4. CASE 24.047, 166 PROSPECT STREET, House, 1857-75 (COLLEGE HILL)
Second Empire; 2½-stories; mansard; Three-bay with heavily hooded entrance; flat-capped dormers.
CONTRIBUTING

Historic District Commission Application
Project: 166 Prospect St.
Address: 166 Prospect St., Providence RI 02906
Date: May 6, 2024

NARRATIVE SCOPE OF WORK

4 WINDOW SCHEDULE - EXISTING
1/4" = 1'-0"

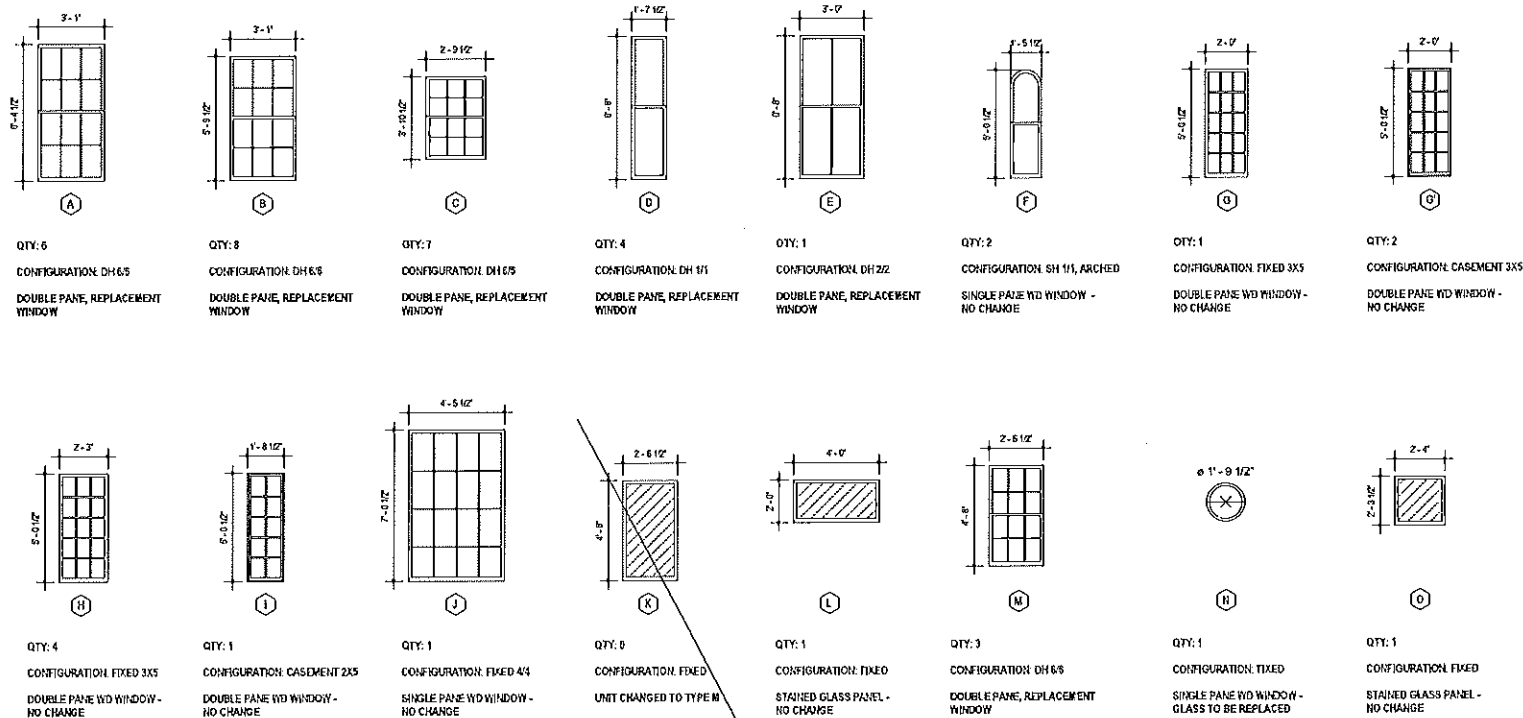
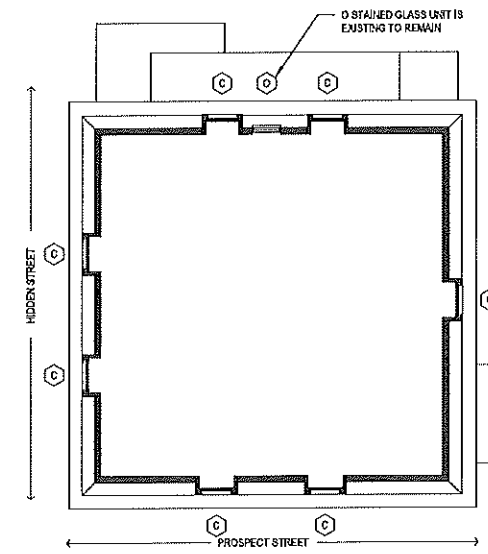
- Evaluation: The existing double hung wood windows are in fair condition. They are a mixture of types with the majority being 6/6 double hung wood windows. The bay window configuration at the north side of the 1st floor contains a mix of 1/1 and 2/2 double hung wood windows. The west side of the house also has a number of stained-glass fixed windows as well as two smaller arched single hung windows. All windows were recently repainted prior to the sale of the house in September; however, the paint continues to chip. This is made worse when the windows are operated. Replacement: the applicants are proposing to replace 28 windows on the first, second, and third floors. The windows will remain the same size as they are currently and will retain their grill configurations—current 6/6 windows will remain 6/6, while 2/2 and 1/1 units will remain 2/2 and 1/1 respectively. One stained glass unit will be replaced with a 6/6 double hung unit to match others of the same size on the west-facing facade. In addition, the applicants would like to add one window-sash on the east side of the house, facing Prospect St., which would infill what is currently detailed as an opening on the facade but covered over with wood shutters. This additional window would match adjacent 2nd floor windows on this facade. The new windows shall be 400 Series Woodwright Double Hung Insert Windows by Anderson. These units have a Fibrex exterior and a wood interior. At present, the applicants are intending to keep all existing storm windows in place. Staff recommends that the storm windows be removed and half-screens be used with the replacement units.

- The work as proposed is in accord with PHDC Standards 2 & 8 as follows: the proposed alterations are appropriate having determined that the proposed construction will be similar in size and appearance to the existing, matching in visual features (Standard 2) and its architectural and historically compatible with the property and district having an appropriate size, scale and form that while diminishing the historic quality of the property will not have an adverse effect on the property or district (Standard 8) while allowing the property to come into compliance with RIGL § 42-128.1-8.
